ST12 Steam Enhanced Extraction: Has criteria for termination of Steam Injection Been Met?

Status as of 11/6/15 Weekly Progress Report

Progress Report
Steam Enhanced Extraction Remediation at the Former Williams AFB ST012 Site, Mesa, AZ
November 4, 2015

Figure 29. NAPL Screening Results and Calculated Benzene Concentrations – Lower Saturated Zone

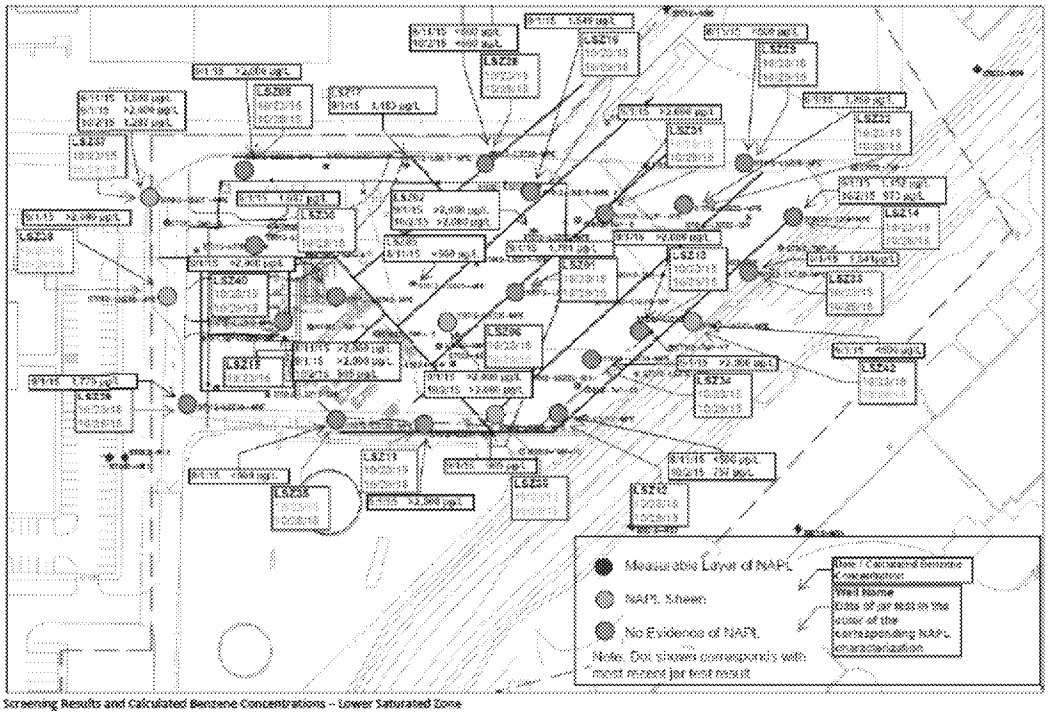
Benzene Concentrations in LSZ Exceed 500 µg/L; Criteria has not been met for LSZ

Figure 28. NAPL Screening Results and Calculated Benzene Concentrations – Upper Water Bearing Zone

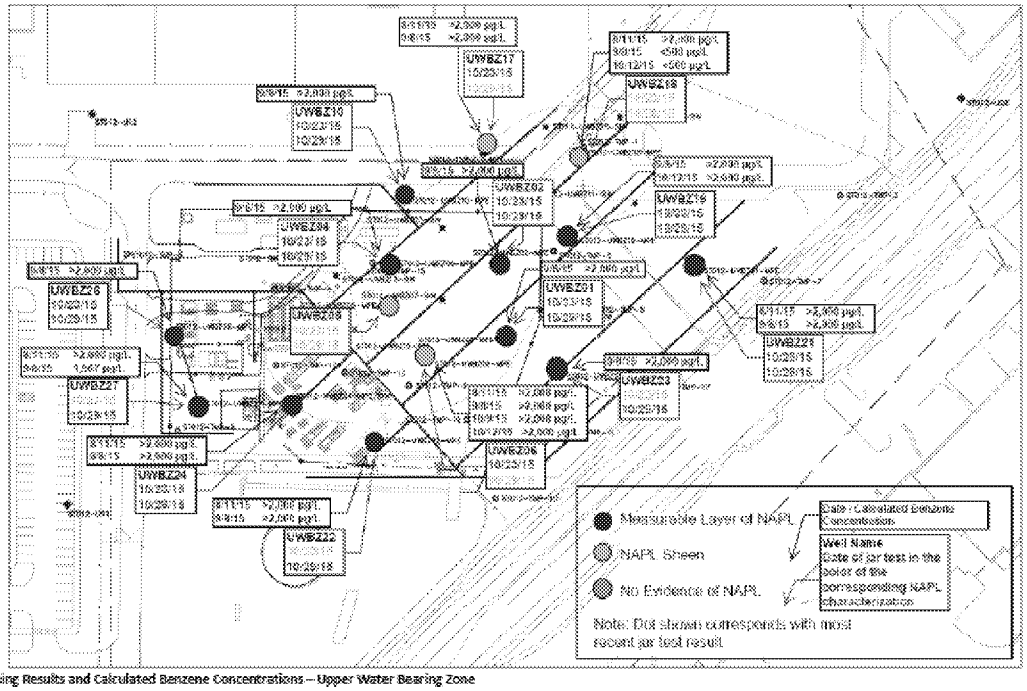
Benzene Concentrations in UWBZ exceed 500 µg/L; significant NAPL present, Criteria has not been met for UWBZ

Figure 27. NAPL Screening Results and Calculated Benzene Concentrations – Cobble Zone

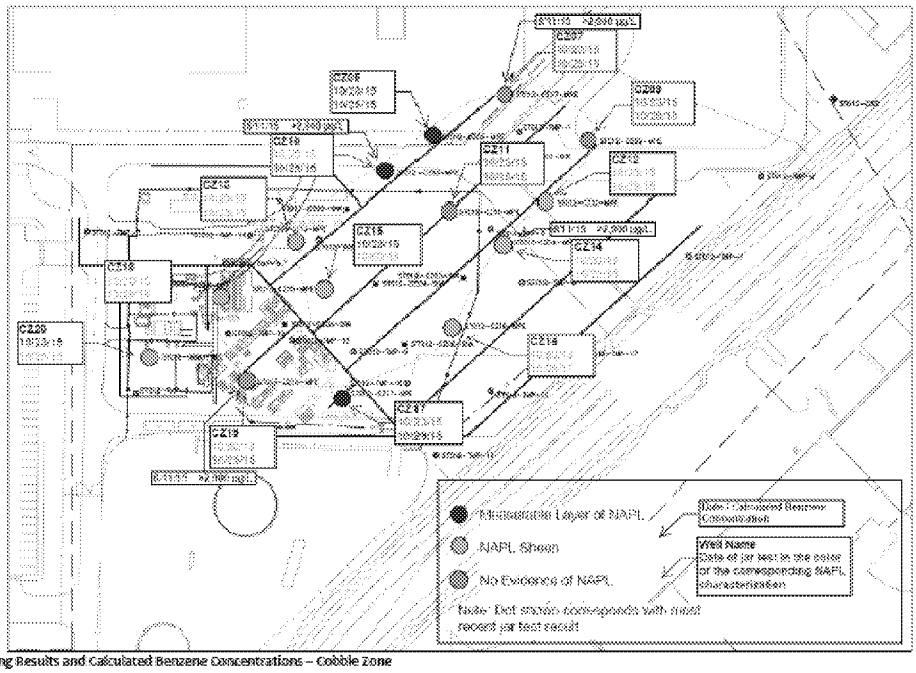
Benzene concentrations Exceed 500 µg/L in CZ, NAPL present; Criteria has not been met for CZ

Figure 4. Daily Mass Removed

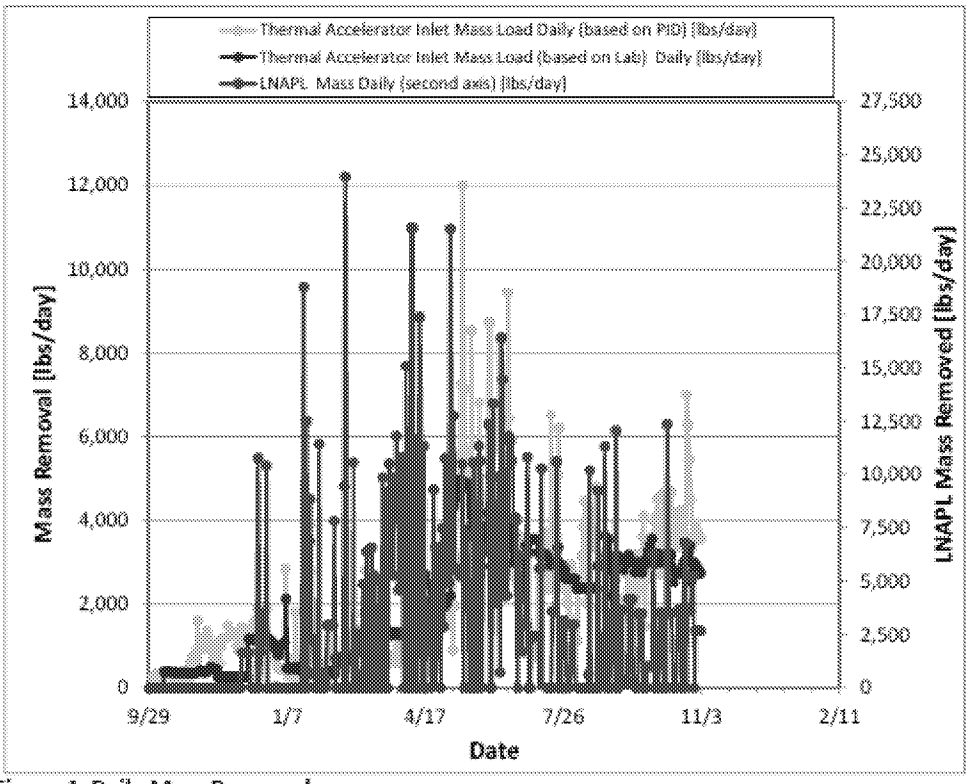
Analysis: Current LNAPL recovery is at 30% of peak removal rate; vapor recovery is 50% of peak removal rate; Criteria for termination of steam injection has not been met. EPA considers the criteria of 10% of the peak mass recovery to be high compared to the mass recovery rates that have been used to support thermal treatment termination at other sites. We cannot support termination of treatment when thousands of pounds of contaminant mass are being extracted daily.

Mass Removal over Time

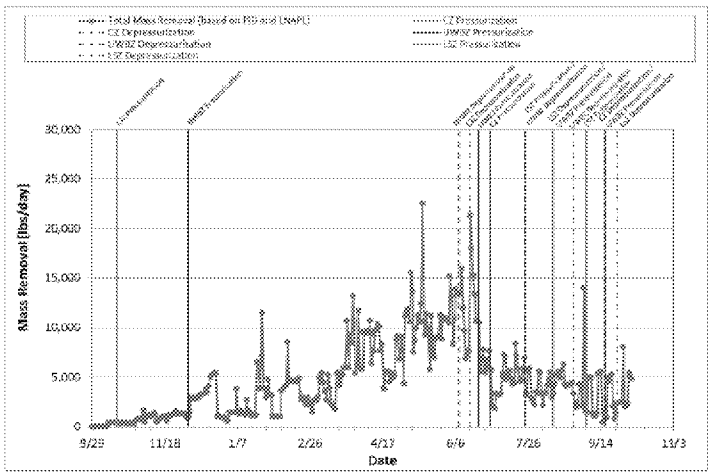
NAPL Recovery was increasing up until the time pressure cycling was imitated. Did decline in recovery rate occur because pressure cycling was initiated early? Consider the analogy of liquid recovery with pressure cycling similar to turning spigot of garden hose on and off….

Wellfield Vapor Influent PID Concentrations over Time

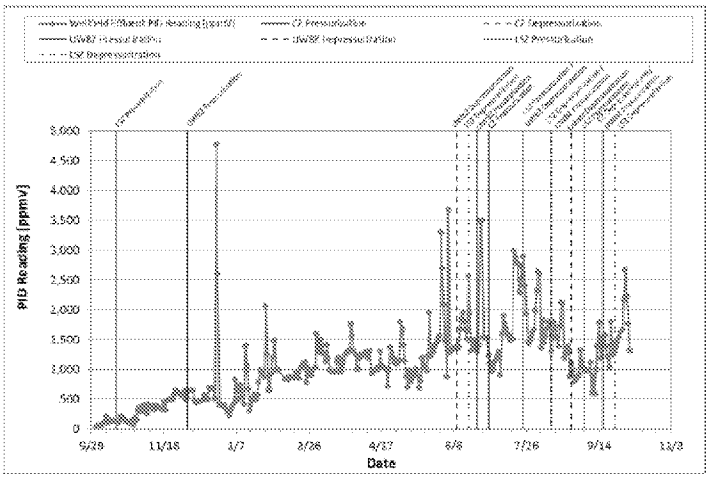
The criteria in the RD/RAWP stating that "the process is repeated . . .until no additional significant increases in effluent vapor phase concentrations occur when steam pressure is reduced" has not been met.

Figure 6. Average Soil Temperatures

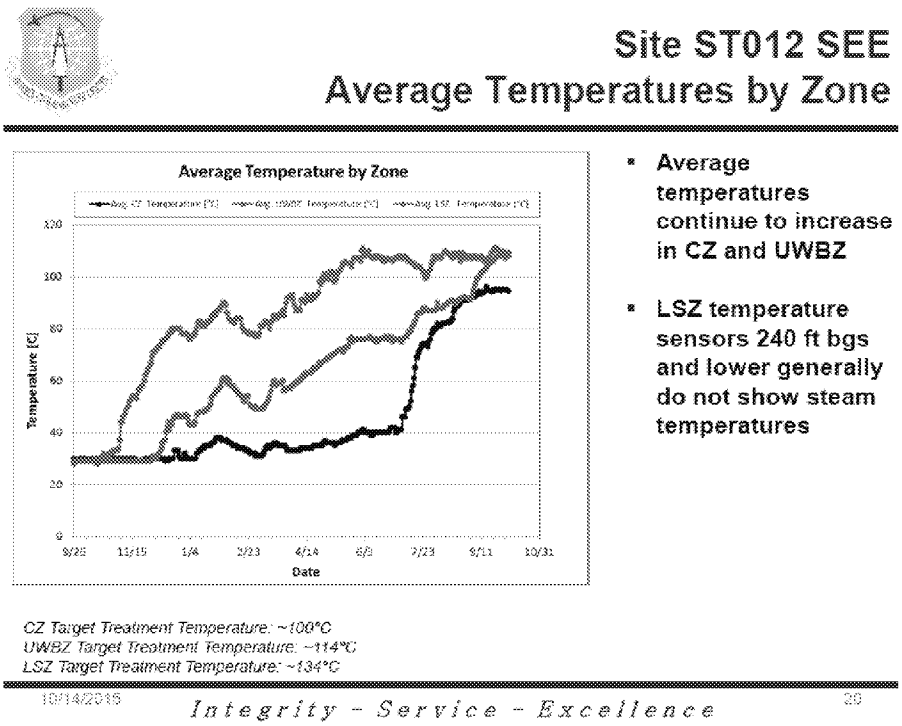
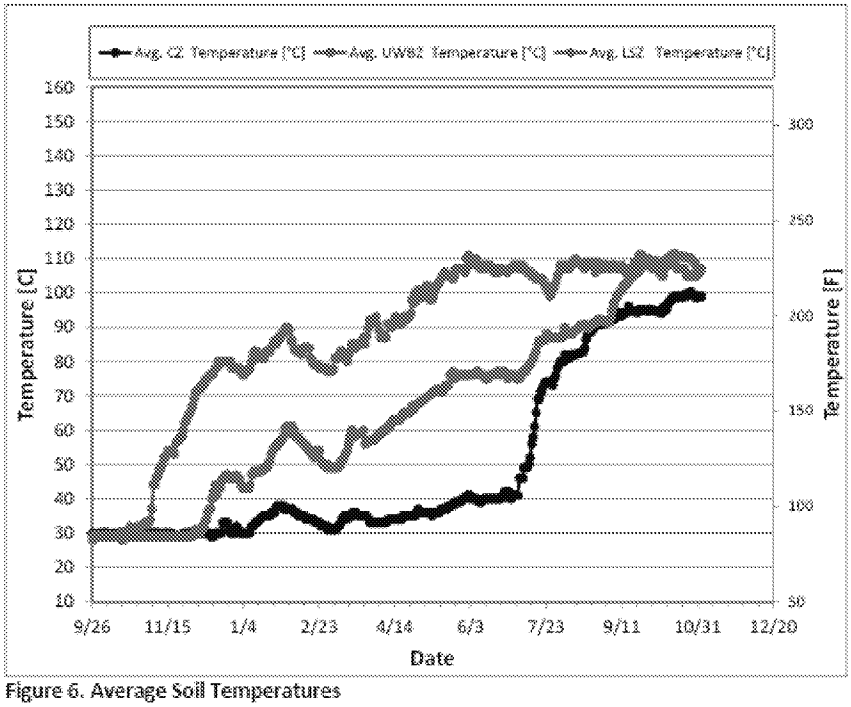
Analysis: According to slide 20 from Oct 15, the target temperature for the CZ is ~ 100C, which has almost been met. The target for the UWBZ is ~114C, which has almost been met. The target for the LSZ is ~134C, which has not been met.
